Amendment proposals to document 7  
further to the 23 May 2013 GFV meeting

**World Forum for Harmonization of Vehicle Regulations****Working Party on Pollution and Energy****Sixty-sixth session**

**UN Regulation No. 49 (emissions of compression ignition  
and positive ignition (LPG and CNG) engines)****Proposal for Supplement 6 to the 05 series of amendments to  
Regulation No. 49 (compression ignition and positive ignition  
(LPG and CNG) engines)****Submitted by the Chair of the informal working group on Gaseous  
Fuelled Vehicles (GFV)\***

"8.1. Engine speeds<sup>57,8</sup>

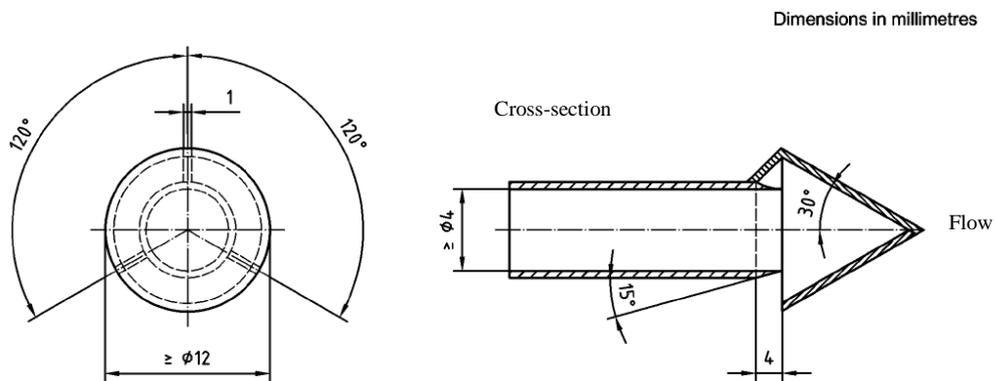
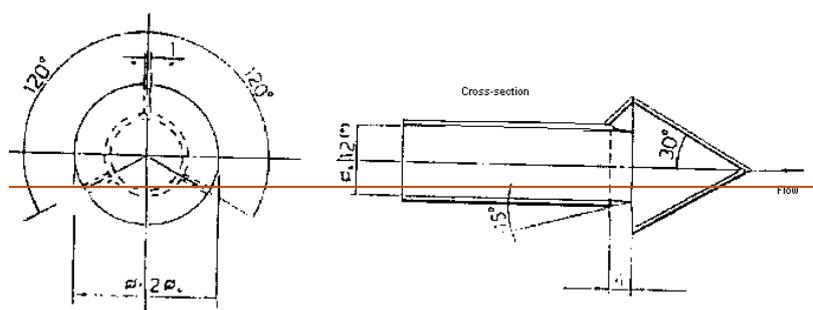
*Annex 1, Appendix 1, Paragraph 8.1.*, amend (also changing footnote reference number from 5 to 7) and add footnote 8, to read:

<sup>57</sup> Specify the tolerance; to be within  $\pm 3$  per cent of the values declared by the manufacturer.  
<sup>8</sup> In the case of Type 1B, Type 2B, and Type 3B of dual-fuel engines (types as defined in Annex 11), repeat the information in both dual-fuel and diesel mode."
